PREDETERMINATION SETTLEMENT AGREEMENT

CP# 02-18-71648
HUD# 07-18-8532-8

unit,” and the “usable kitchens and bathrooms.”¹ Complainant specifically alleged at 3195 Shire Lane, The Overlook Apartments (“Overlook”), one feature in the common areas and two features within one of the covered units appeared inaccessible to a person utilizing a wheelchair for mobility – (1) the height of the midlines of the keyholes of the mail compartments for four of the ground-floor units at one of the kiosks for Building 3195 were measured at 58” (Units 1 and 9) and 55 ¼” (Units 2 and 10), which are both higher than the 54”-maximum allowed for a parallel approach by persons using a wheelchair; (2) the height of the interior threshold at the doorway to the balcony in Building 3195 Unit 3 was measured at 1 ½”, which exceeds the ¼”-maximum allowed for interior thresholds at sliding glass doorway without 1:2 beveling, which was observed to be lacking; and (3) the distance between the refrigerator and opposing countertop was measured at 36 ½” in Building 3195 Unit 3, which is less than the required minimum clearance of 40”.

BUILDING 3175 UNIT 7 – WALK-IN CLOSET

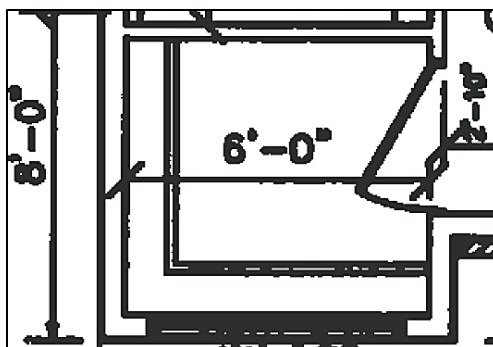
2) The ICRC Investigators took measurements of the clear opening width at the secondary doorways within all inspected units. The clear opening width of the doorway at the walk-in closet in Building 3175 Unit 7 measured 27 5/8”.⁶

Based on the scaled drawing above, clear opening width of the doorway to the walk-in closet in Building 3175 Unit 7 was designed to be about 32” because the door itself was designed to be 34” wide, and the clear opening widths are typically 2” less than the width of the door.⁸ As designed, the doorway would have been compliant with the 31 5/8”-minimum requirement. However, as built, the clear opening width of the secondary doorway to the walk-in closet in Building 3175 Unit 7 is less than the 31 5/8”-minimum requirement. This doorway is too narrow, rendering it unusable by persons using wheelchairs.⁹

- 2) ICRC agrees with Respondents' proposal to (i) either remove the door to the walk-in closets in the 1BR units or replace the current doorway with a doorway to increase the clear opening width for this doorway to no less than 32"; (ii) complete this retrofit at the units that are currently vacant within 30 days from the date of the Closing Letter from ICRC; and (iii) to notify the current tenants at the units currently occupied to inquire which of the two retrofits they prefer. If tenants do not want either option done at that time, Respondents will complete one of the two retrofits described above within 30 days of the date that tenant vacates the unit and before that unit is rented to the next tenant.

- (b) Respondents agree to either remove or replace the door panel and door stop at the walk-in closet in Building 3175 Unit 7 to increase the door-opening width to $\geq 31 \frac{5}{8}$ ”.

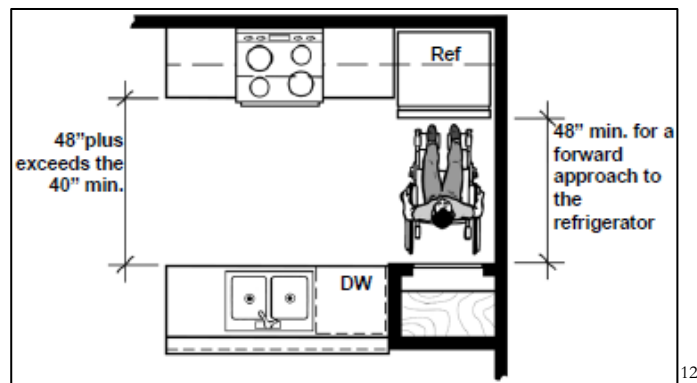
4) The height of the top control buttons of the thermostat in Building 3175 Unit 7 was measured at 48 1/2", which exceeds the 48"-maximum height.¹⁰

Outlets, light switches, and environmental controls must meet mounting height restrictions.

The heights of the thermostat in Building 3175 Unit 7 would have been compliant with the 48"-maximum height requirement as referenced above if installed according to the instruction in the plans. But, as built, it is too high, rendering it unusable by persons using wheelchairs.

- 4) ICRC agrees with Respondents' proposal to relocate the thermostats in all covered ground-floor units, so that all of the controls are at a height not exceeding the 48"-maximum height within 30 days from the date of the Closing Letter from ICRC.

(b) Respondents agree they will vertically relocate the thermostats in all units to a lower height, such that the display screen and all operating buttons do not exceed maximum height of 48”, as required by the Manual.

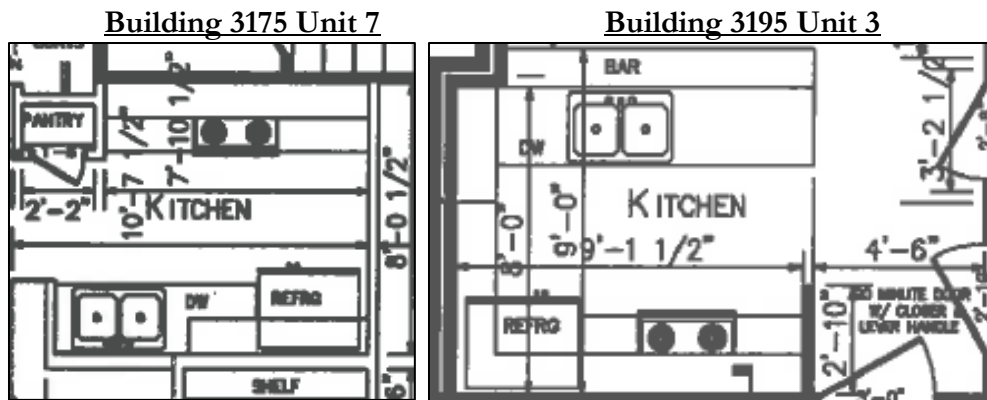
5) The following illustration indicates the clear floor space requirements as applicable to refrigerators located adjacent to a side wall in galley-style kitchens:

When a refrigerator is located against a sidewall in a galley kitchen, as shown in the diagram above, a centered-parallel approach by someone in a wheelchair is not possible because the sidewall is less than 24" from the midline of the refrigerator. A centered-forward approach is the only other possible approach, which requires the clearance between the front face of the refrigerator and the opposing countertop to be 48". In order to achieve this clearance, all of the features (i.e., countertops, appliances, etc.) on either side of the galley kitchen must also be 48" away from each other. In Building 3175 Unit 7 and in Building 3195 Unit 3, the midline of the refrigerator is estimated to be about 15" from the adjacent wall based on the 30" side of the 30"-by-48" drop cloth that was placed on the floor flush with the front face of the refrigerator door and the adjacent baseboard. The midline of the refrigerator in both of these units is less than the 24"-

The width of the path between the refrigerator – which is in the same configuration as shown and described above – and the opposing counter, excluding the door handles, was measured at 38 1/2” in Building 3175 Unit 7 and 37 7/8” in Building 3195 Unit 3, which are both less than the 48”-minimum required for this refrigerator configuration.¹³

The width of the path in the kitchen of Building 3175 Unit 7 and Building 3195 Unit 3 was designed to be about 42”. The midlines of the refrigerators were designed to be about 15” away from the wall in both units. As designed and built, the path in these kitchens is less than the 48”-minimum, which is required because the only approach possible at the refrigerator is a forward approach given the location of the refrigerator at the closed end of the kitchen. These violations render these kitchens unusable by persons using wheelchairs.

- 5) ICRC agrees with Respondents' proposal to move the refrigerator to an adjacent wall so that there will be a clear floor space that measures no less than 30" x 48" and is centered at the refrigerator in Building 3175 Unit 7 and in Building 3195 Unit 3, and at the other similarly-designed units. However, ICRC disagrees with the portion of Respondents' proposal that requires tenants to request this retrofit before this deficiency is corrected. Instead, ICRC will allow Respondents to give tenants the option of rejecting this retrofit. At units where current tenants reject the retrofit, ICRC will require that this retrofit be completed within seven days from the date those units are vacated by the current tenants. Otherwise, ICRC will require that future tenants are not given the option to reject this retrofit.

(b) Respondents agree to move the refrigerator to an adjacent wall near the kitchen at Unit 7 in Building 3175 and at Unit 3 in Building 3195 so that there will be clear floor space measuring no less than 30” x 48” centered on the refrigerator for either a parallel or forward approach.
